REPORT REFERENCE: CAP020823 – 4.1
CITY OF MARION
COUNCIL ASSESSMENT PANEL AGENDA
FOR MEETING TO BE HELD ON
WEDNESDAY 2 AUGUST 2023

Originating Officer:	Matt Falconer Development Officer – Planning
Applicant:	PC Infrastructure Pty Ltd
Development Description:	<p><u>Original Development Description</u> Additions and alterations to the existing control building, reconfiguration of the existing on-site carparking, introduction of a convenience drive-thru, 3-metre-high acoustic fence, dog wash and vacuum facilities and a 3.3m pylon with double sided digital signage panel.</p> <p><u>Revised Development Description</u> Additions and alterations to the existing control building, reconfiguration of the existing on-site carparking, introduction of a convenience drive through, 2.4-metre-high acoustic fence, dog wash and vacuum facilities and introduction of hours of operation of 6am to 10pm for the drive-through component</p>
Elements:	Fence Advertisement Retail Fuel Outlet Other – Drive Through Coffee and Dog Wash
Site Location:	216-220 Seacombe Road, Seaview Downs

Attachment III: Compromise Proposal Plan and supporting documentation

Original Proposal – Northern Elevation**Compromise Proposal – Northern Elevation****Original Proposal – Southern Elevation****Compromise Proposal – Southern Elevation****Compromise Plans**

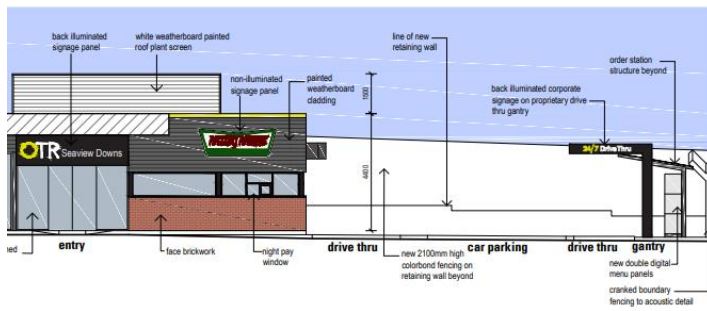
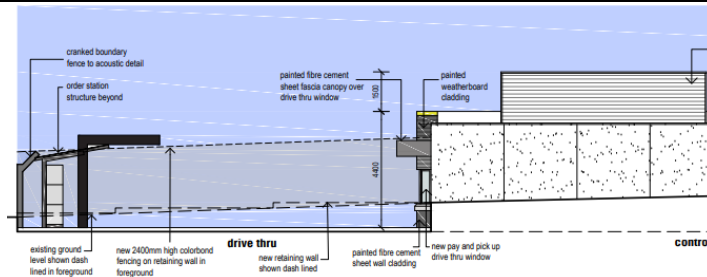
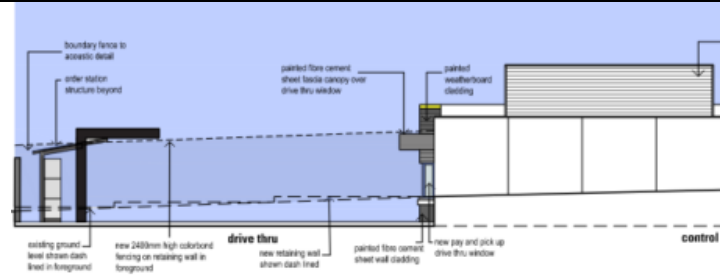
As detailed above, the compromise proposal seeks to restrict the proposed drive through's operating hours from 24 hours to between 6 am and 10 pm. In addition, the amendments result in a change to the design of the acoustic fencing along the southern and western boundaries of the subject site.

I have provided a comparison of the effected elevations below with the first three images being that of the original proposal and the second three being the compromise proposal.

The revised plans detail the change to the acoustic fencing which is reduced in height along the length of the western boundary to a maximum height of 2.4 metres. The proposed 2.4 metre acoustic fence is the same height as the existing fence, which currently comprises a 1.8 metre high solid colorbond fence with 600 millimetre lattice above. The original proposal sought to have a 2.4 metre high fence with a 45 degree cantilevered section extending to 2.9 metres in height as per the diagram below, which the compromise has now removed.

Whilst acknowledging the proposed fence is to be completely solid to a height of 2.4 metres, the additional height above 2.1 metres (a fence height not requiring approval) shall not result in any unreasonable amenity impact in relation to the visual appearance. The level of overshadowing resulting from the existing 600 millimetre lattice screen being modified to solid fencing will increase, however I am not of the opinion the extent of the increase shall have adverse impacts on the amenity of adjoining properties from an overshadowing perspective. Due to the orientation of the site, the shadowing will occur during the morning with the dwellings able to obtain unrestricted sunlight during

the middle part of the day. As such, I am of the opinion the compromise proposal addresses the reason for refusal number 5 (highlighted below).

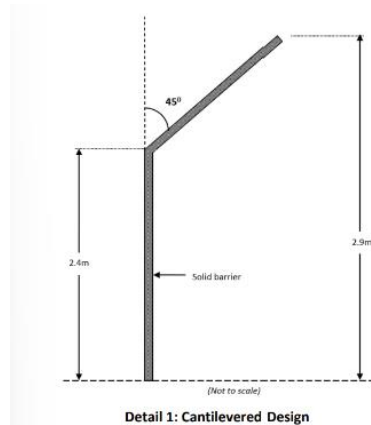
With the removal of the pylon sign, the reason for refusal numbered 6 highlighted below is considered to be adequately addressed.

- 6. Does not satisfactorily meet PO 4.2 of the Suburban Activity Centre Zone as the proposed freestanding advertisement does not adequately avoid visual clutter or positively respond to the site's context.**
